**Planning Board Meeting Agenda
Brunswick Town Hall
85 Union Street – Council Chambers
Tuesday, February 10, 2026 @ 6:00 PM**

4. **Case No. 25-059 – MaineHealth Mid Coast Cancer Center Renovation:** The Planning Board will review and act upon a **Site Plan Amendment** application submitted by Pine Tree Engineering on behalf of the property owner, Mid

Landscaping Comments	Applicant Response
1. Add 10 evergreen trees at 10' o.c. spacing along proposed treelines	The proposed trees have been added to AS1.00 Proposed Site Plan.

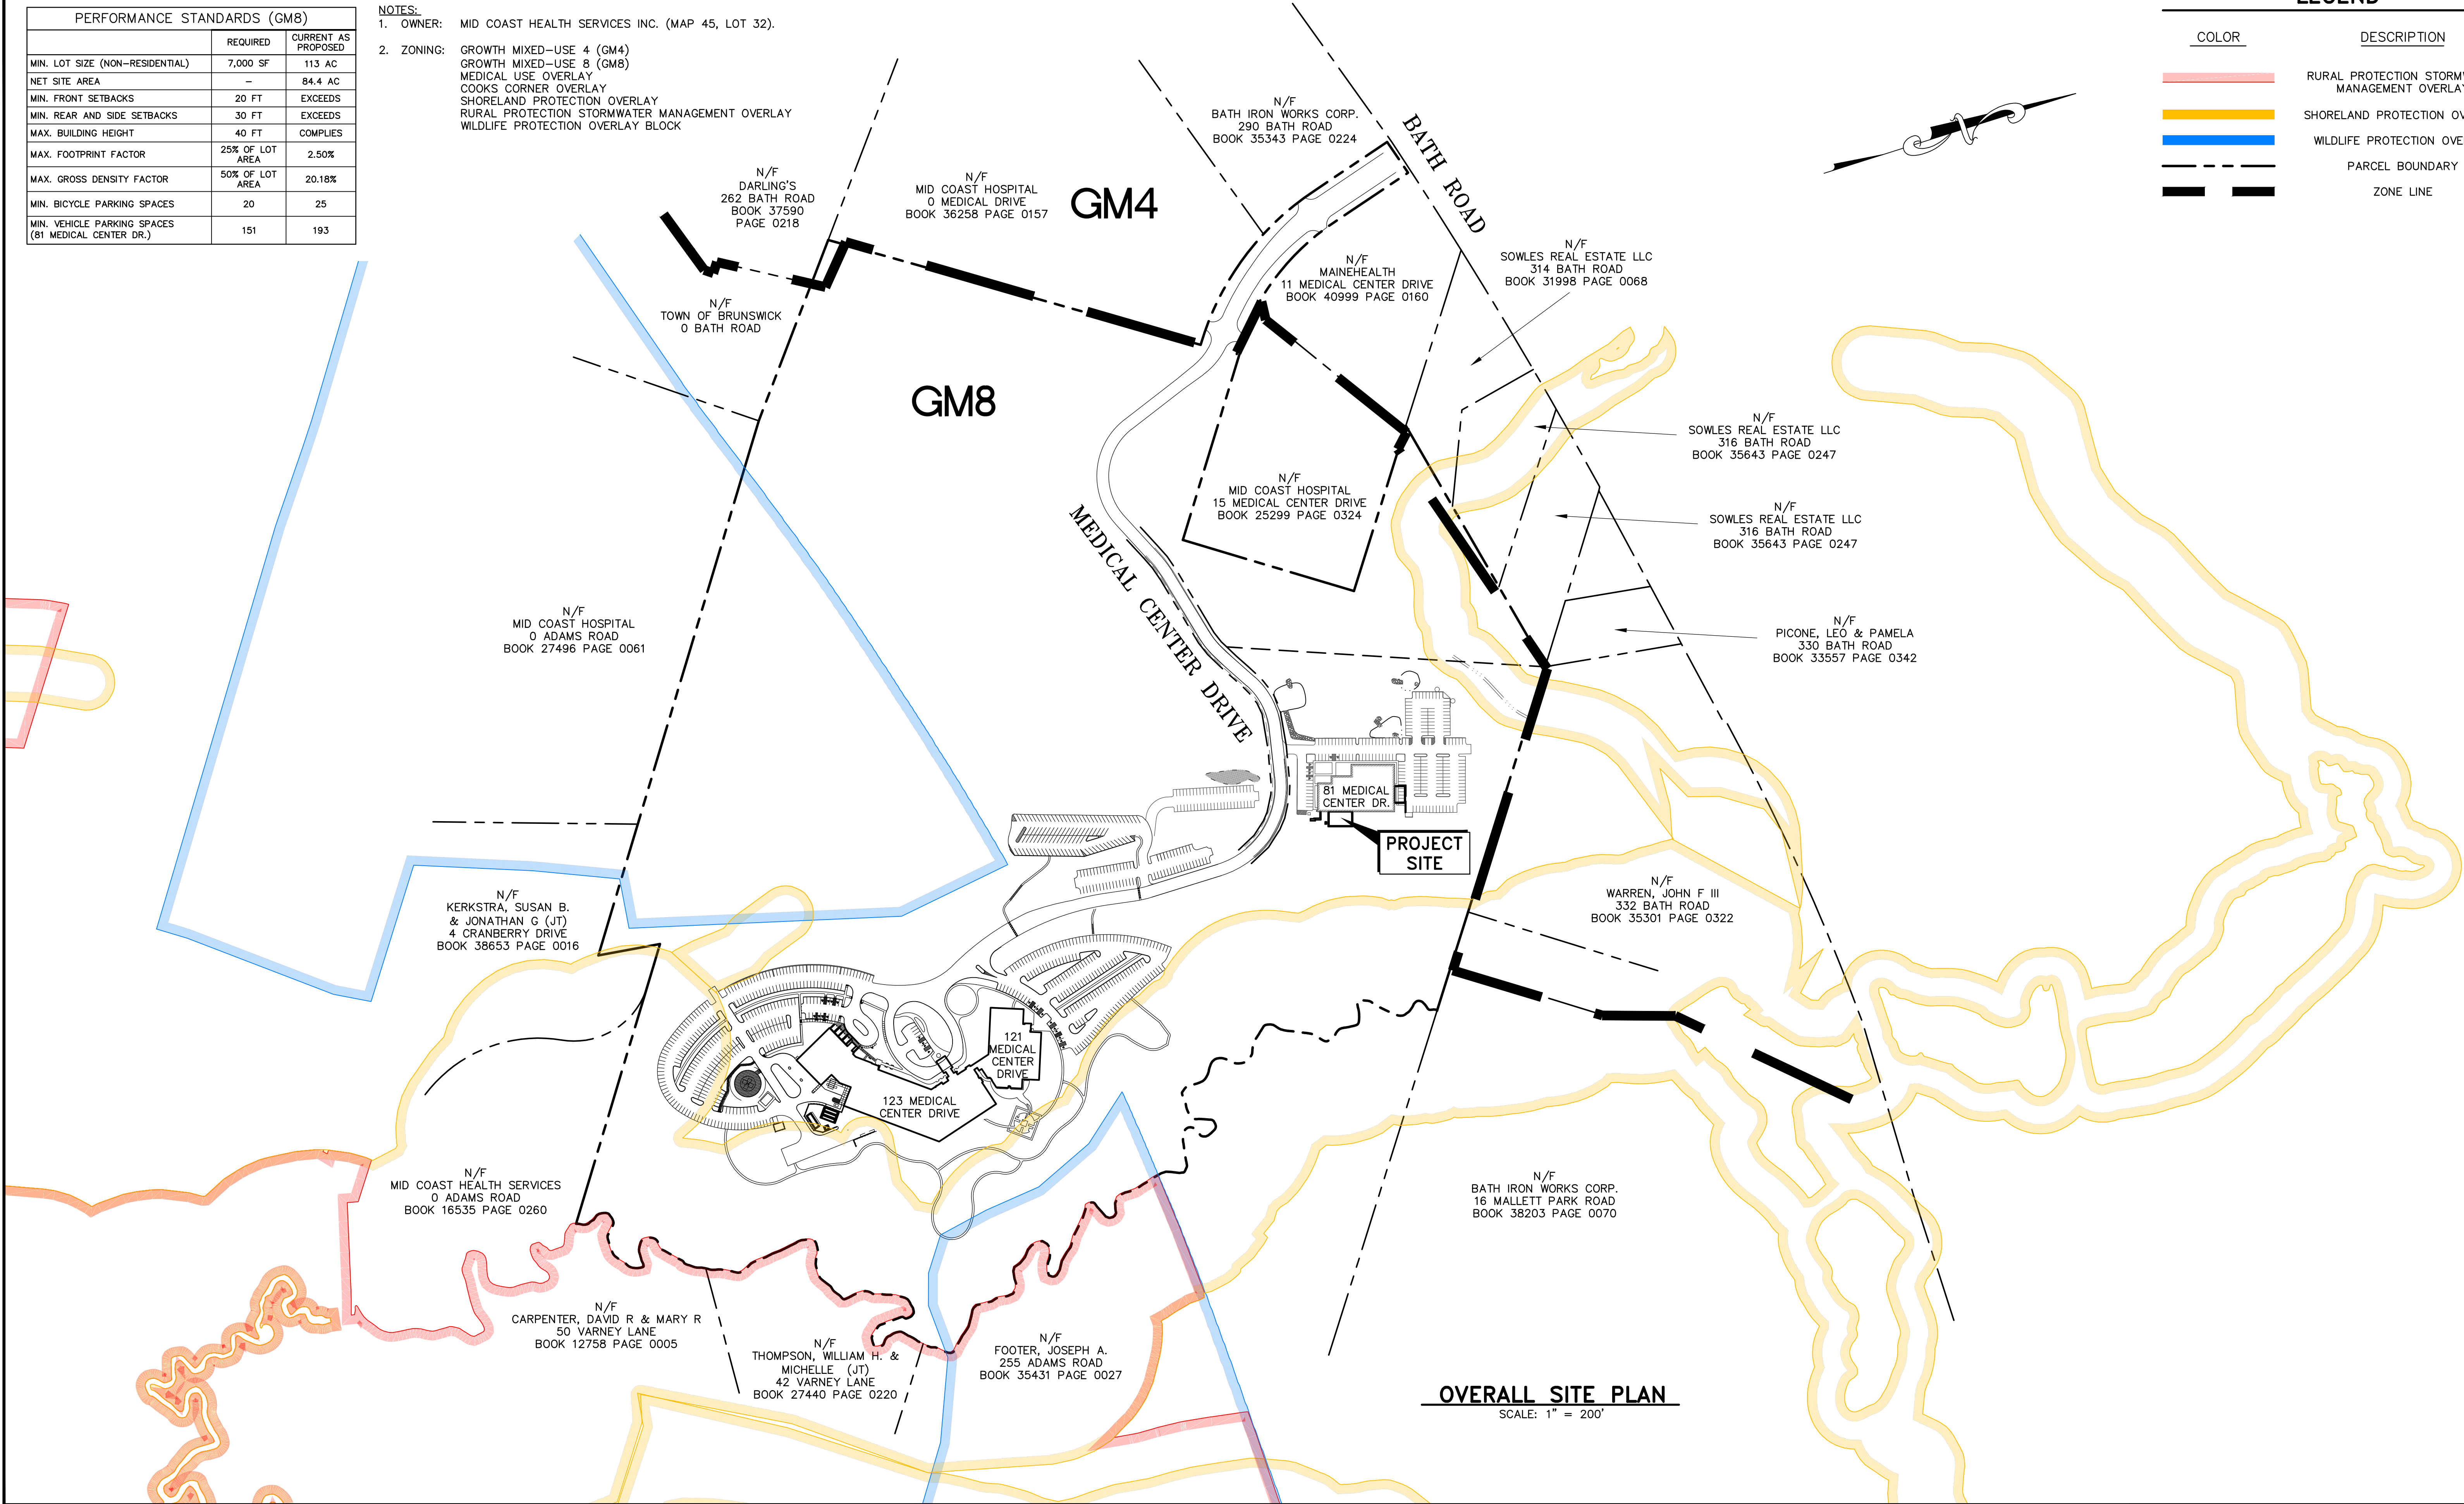
9. Add table of requirements plans (dimensional standards, density standards)	See Exhibit 2: Overall Site Plan.
10. Create overall site plan that shows entire parcel to be included in the application	See Exhibit 2: Overall Site Plan.

14. Provide updated mapping, including Town overlays. This will be shown in #10 above.	See Exhibit 2: Overall Site Plan.
15. Reach out to Maine Natural Areas Program and IF&W for existing sensitive/threatened habitat/species on-site. Email is sufficient	See Exhibit 7: Environmental Review.

Section 3.4 Façade Requirements, and within 3.4.j.

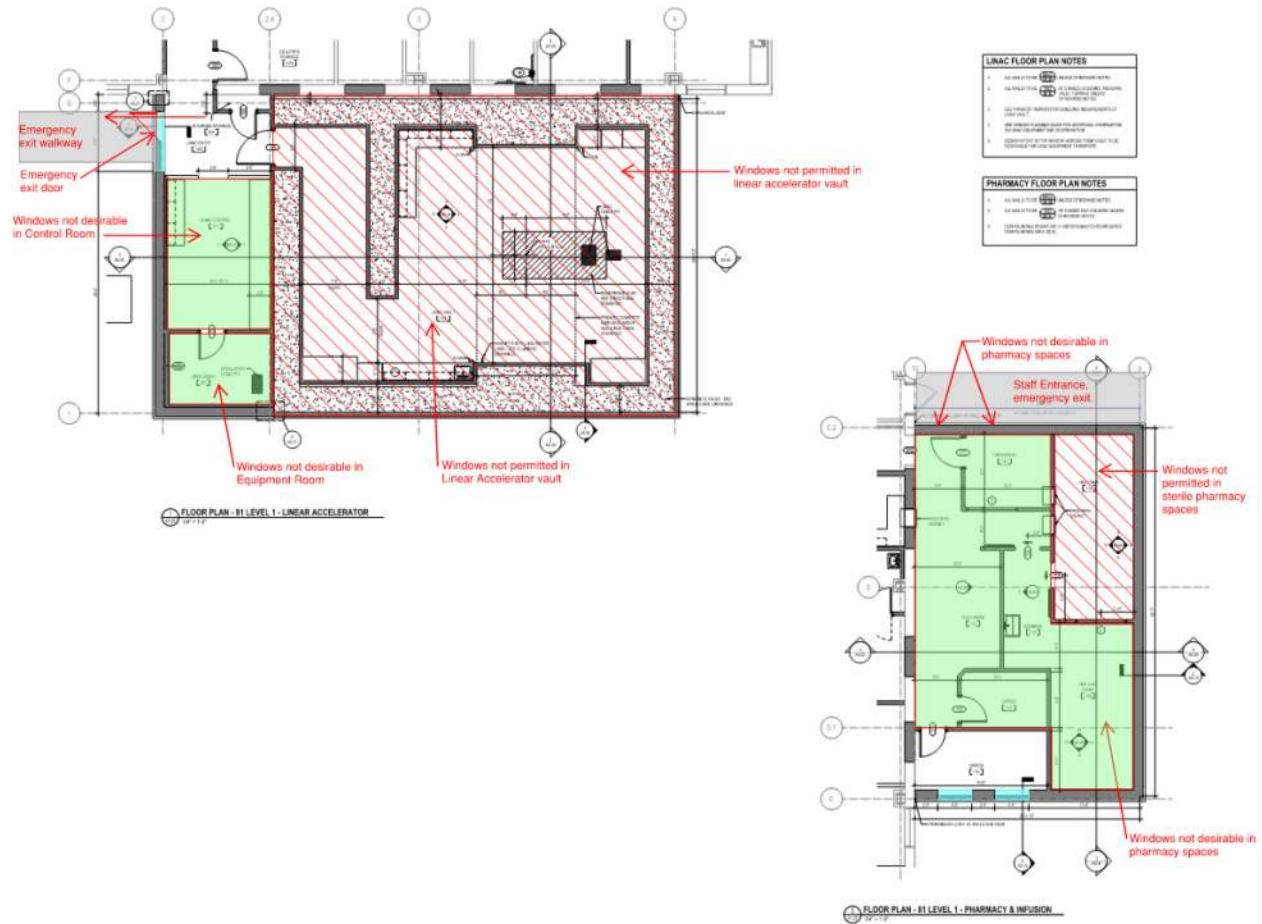
3. Add ornamental grass along parking lot side of pharmacy, near bollards	See Section B-B on AS3.00 Civil Details
Architecture Comments	
4. Review Cooks Corner Design Standards, specifically Section 3.4 Façade Requirements, and within 3.4.j.	See Exhibit 8: Cook's Corner Design Standards Narrative.
Engineering Comments

The two additions to 81 medical center drive are secondary facades according to the definition in Section 3.4 Façade Requirements item C.

The design of these additions take into account the scale, materials and colors of the existing building, by complementing these colors and materials rather than attempting to copy directly as it is difficult to match brick and precast that have weathered for 18 years.

SHEET TITLE AND NUMBER:
AS1.00
PROPOSED SITE PLAN

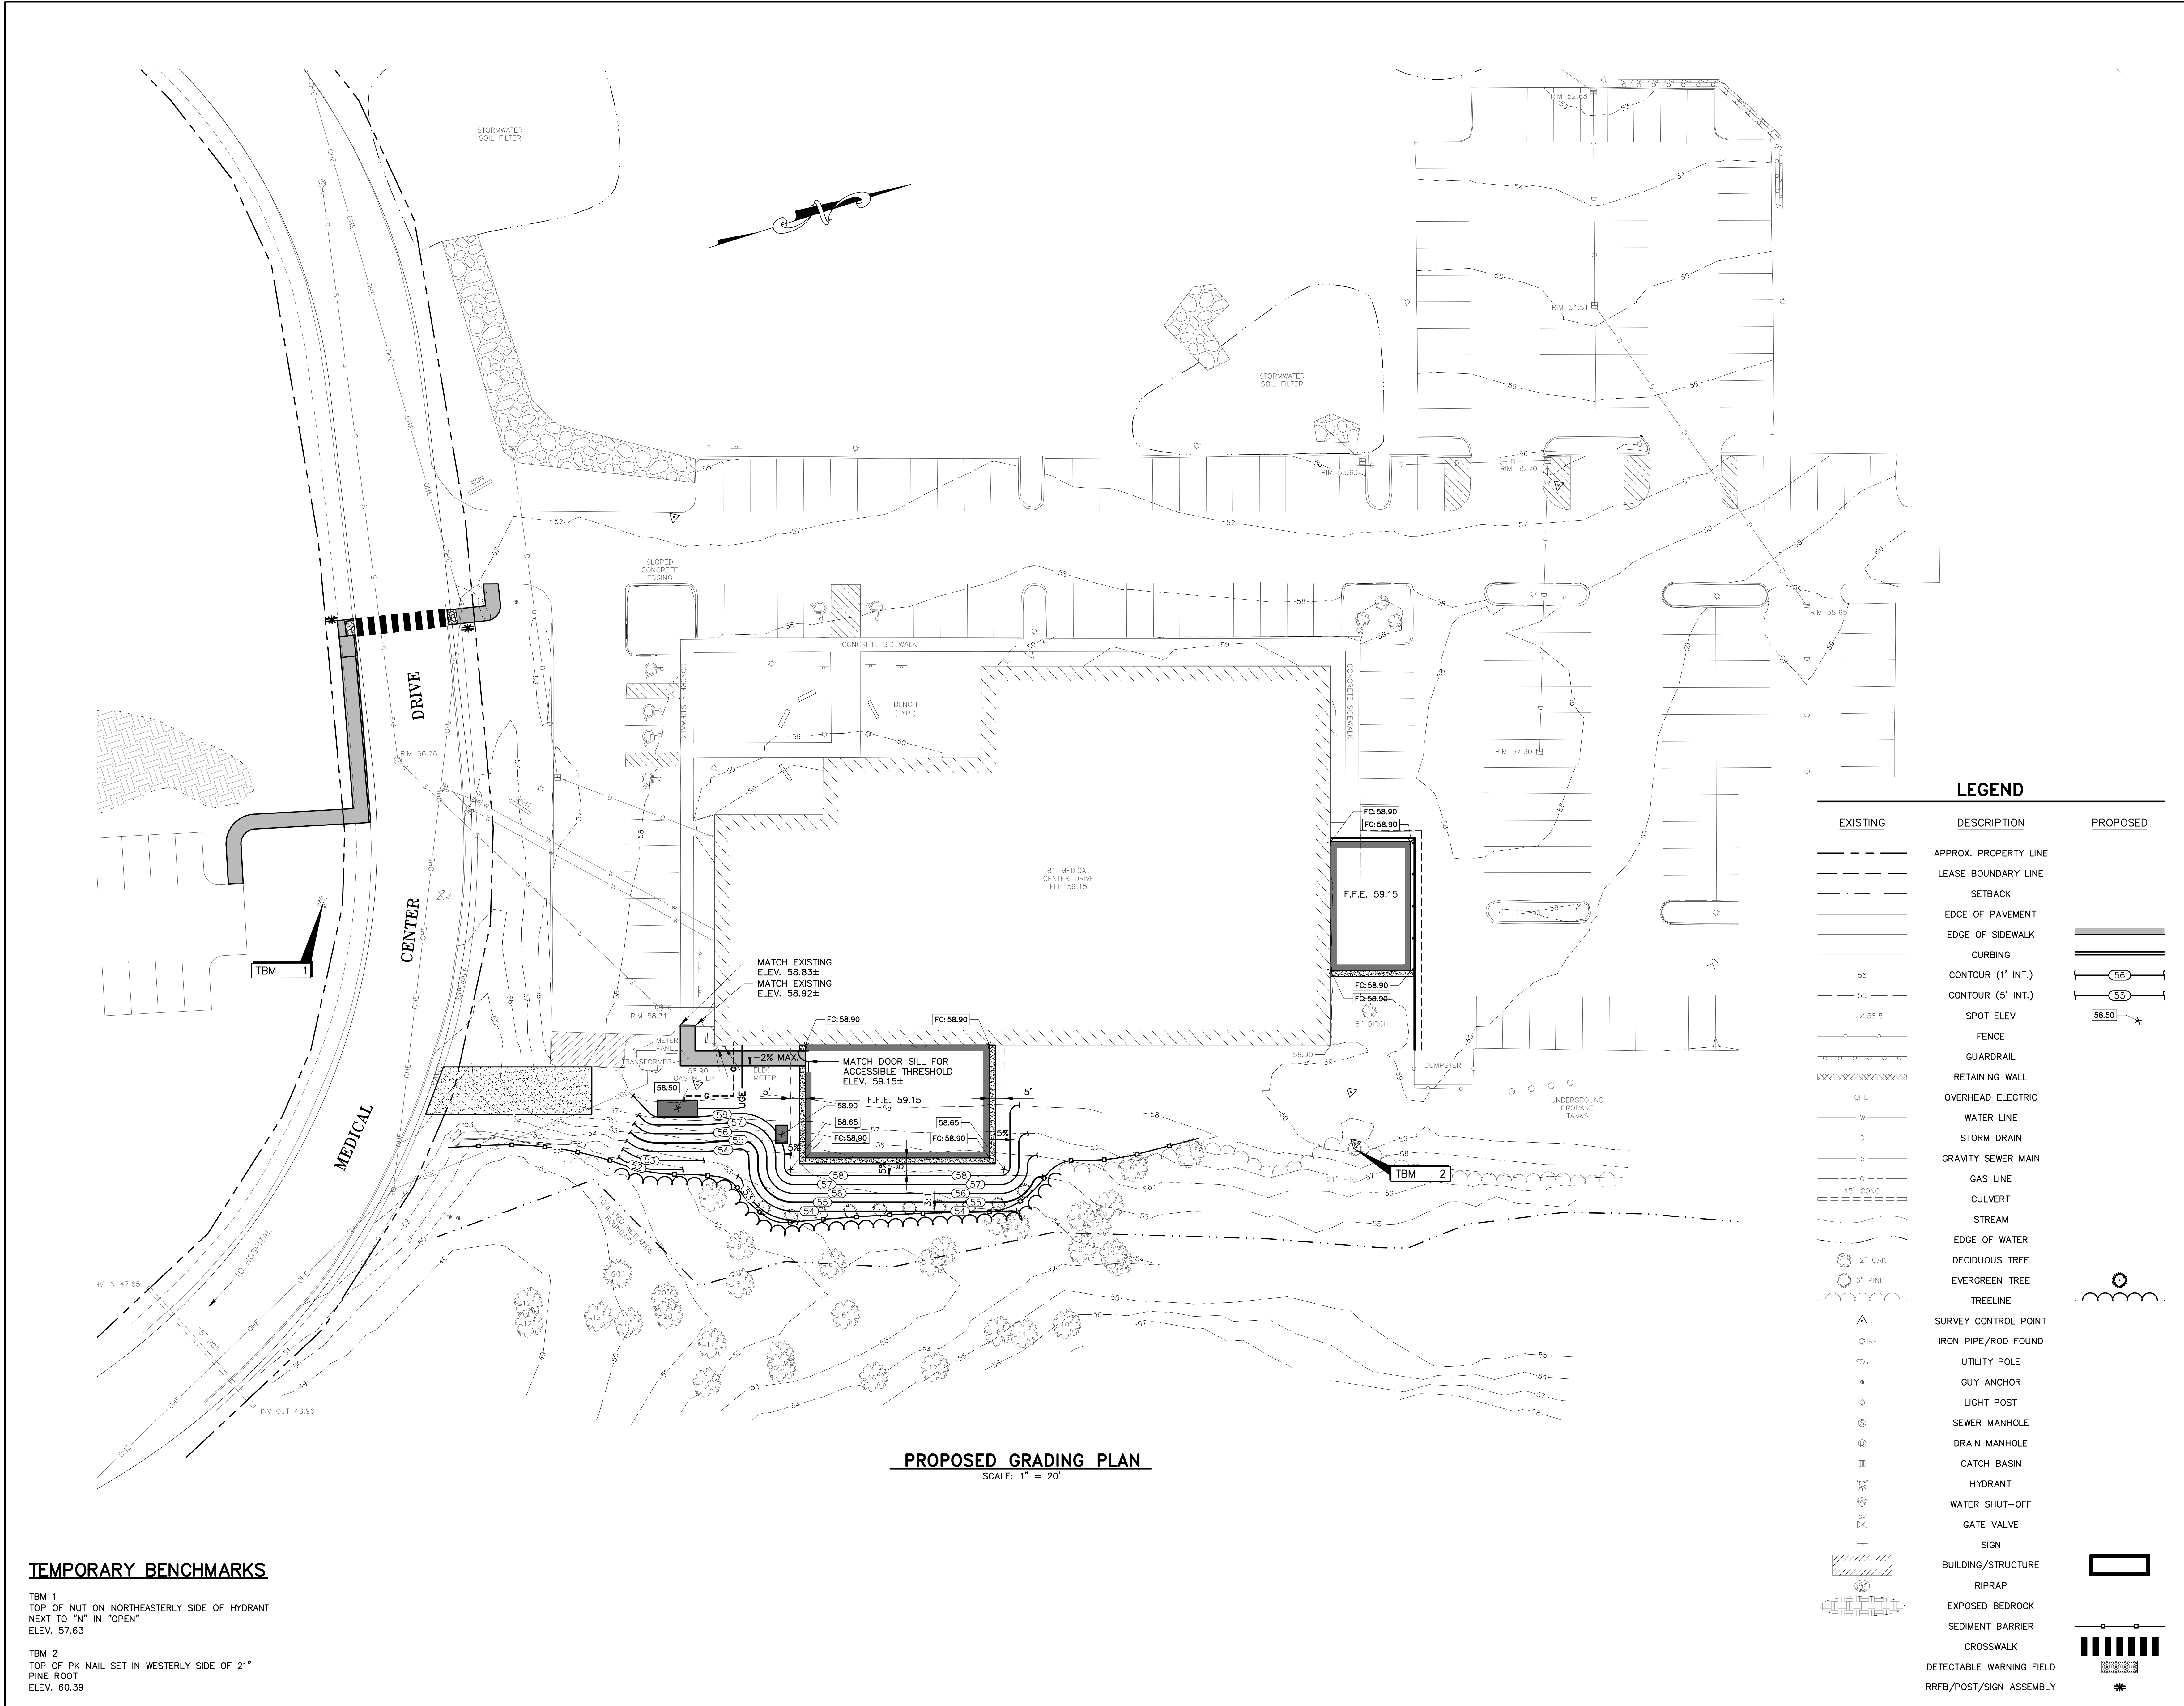
6. Add Erosion Control Barrier linework to plans	Linework for the temporary sediment barrier has been added to AS1.00 Proposed Site Plan.
7. Add bicycle rack locations and callouts to plan (min. 13 spaces)	The proposed bicycle rack has been added to AS1.00 Proposed

Site Plan.
8. Add callouts for sediment sack to inlets	A callout for Temporary inlet protection has been added to AS1.00 Proposed Site Plan
General Comments
